**PORT COLBORNE QUARRIES INC. – PIT 3 EXTENSION
MNR FILING NO. 626511
ARA APPLICATION FOR A CATEGORY 2 (QUARRY BELOW WATER)
CITY OF PORT COLBORNE, REGION OF NIAGARA**

We acknowledge receipt of your email correspondence dated June 7, 2021 wherein you provided formal Ministry of Transportation (MTO) comments to the above noted proposed quarry application. This letter is in response to those comments.

IBI	IBI GROUP Suite 101 - 410 Albert Street Waterloo ON N2L 3V3 Canada tel 519 585 2255 ibigroup.com	
	FIGURE NAME Surface Water Drainage During Extraction Operation	FIGURE NO. REVISION 1 1

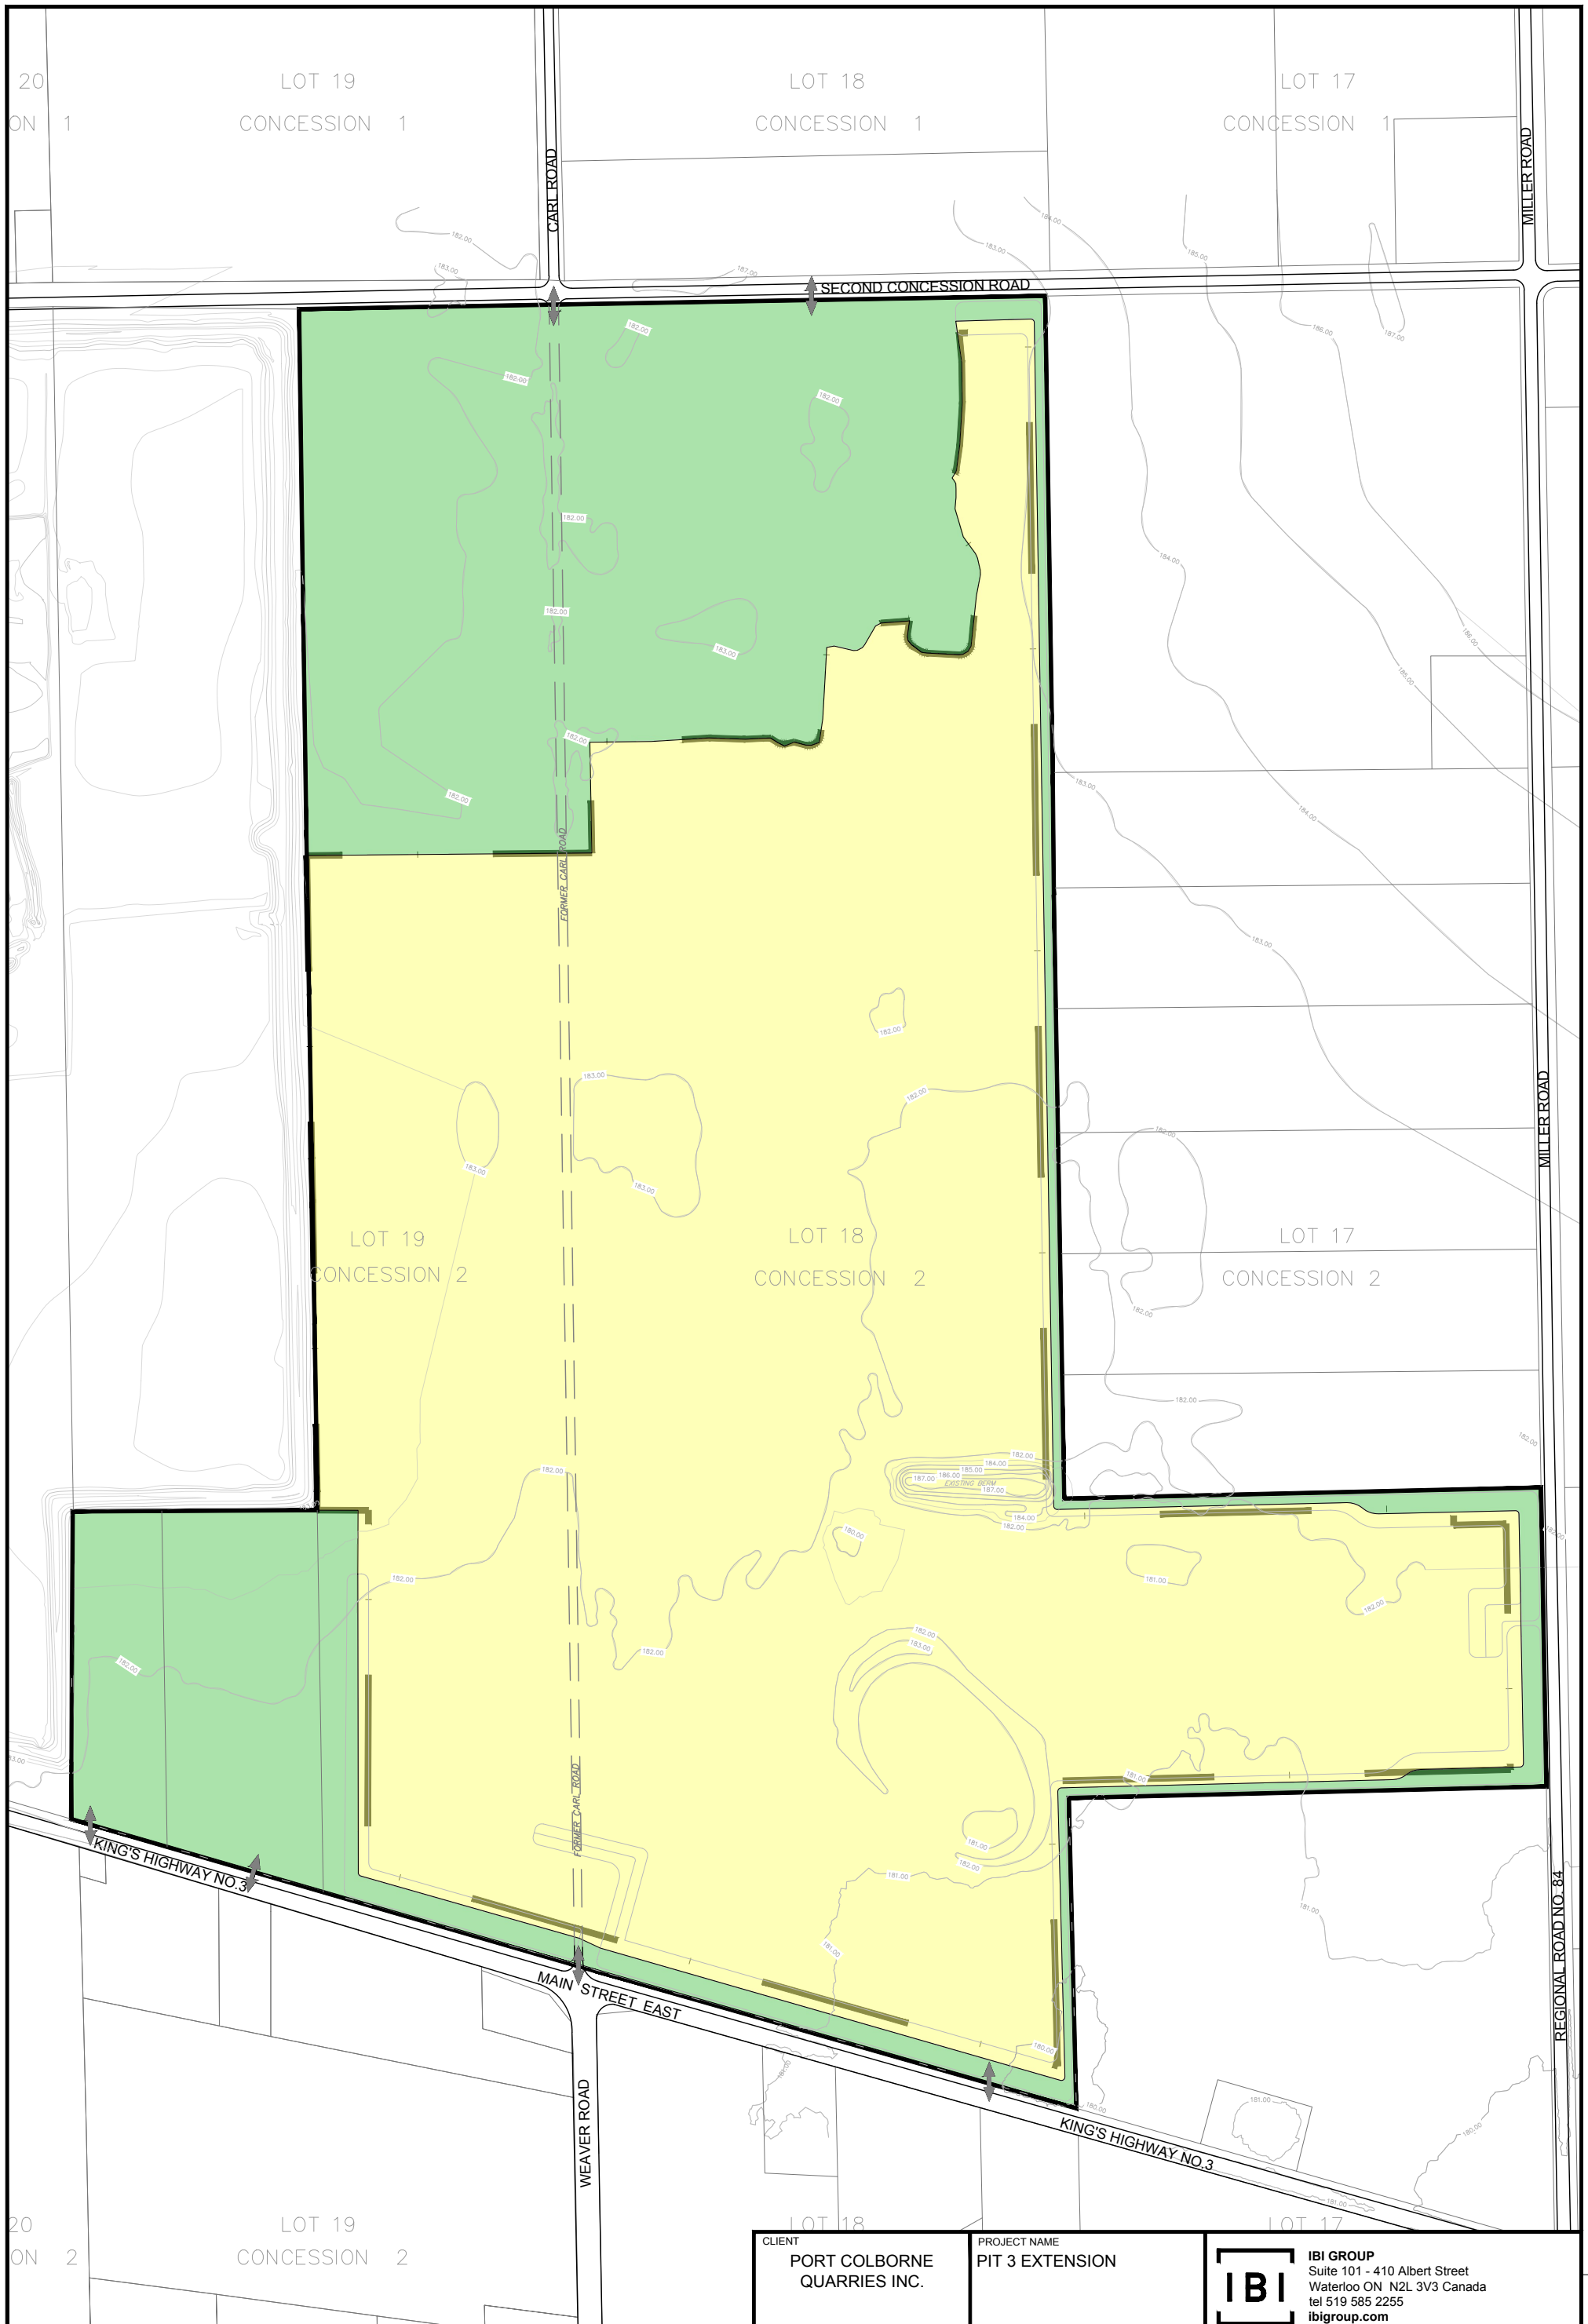
1. The post to pre-development flow condition to be met for 5, 10, 25, 50 and 100 year storm events at all outlets from the proposed Pit 3;

The surface water engineering consultant retained by PCQ Inc. is Golder Assoc. and they have concluded that this type of analysis and comparison is best suited to conventional stormwater management with passive gravity outflows. The proposed Pit 3 Extension does not consider use of that type of stormwater control; instead, all drainage from the Pit 3 Extension (from top of perimeter berms inward) will be directed to a sump, where it will be detained long enough for suspended solids to settle, prior to it being pumped out of the quarry to the receiving watercourse at a constant flow rate.

The pump will operate as required to maintain suitable working conditions in the quarry and variable precipitation inputs will be handled by operating the pump for different durations each day. The peak outflow rate during any of the aforementioned storm events will be limited to the pump rate, which is subject to approval by MECP on the site Environmental Compliance Approval (ECA). During the initial phase of extraction of the Pit 3 Extension, the existing pump rate is expected to be sufficient for dewatering

With regard to drainage from the 'top of the perimeter berms outward', it will be minor in nature as it will only capture the exterior half of the prescribed 30.0 metre setback for the abutting roads (Provincial Highway 3, Regional Road 84, [Miller Road] and City of Port Colborne - Second Concession Road). Roadside ditches which are beyond the property limits will not be disturbed and as such, all peripheral site drainage will continue to be directed to these ditches. Furthermore, the proposed perimeter berms will be vegetated (native grass seed) and designed with a maximum 3:1 slope, ensuring that silt/erosion is minimized.

Refer to Figure 1 – Surface Water Drainage During Extraction Operation and Figure 2 – Pre-Extraction Surface Water Drainage.
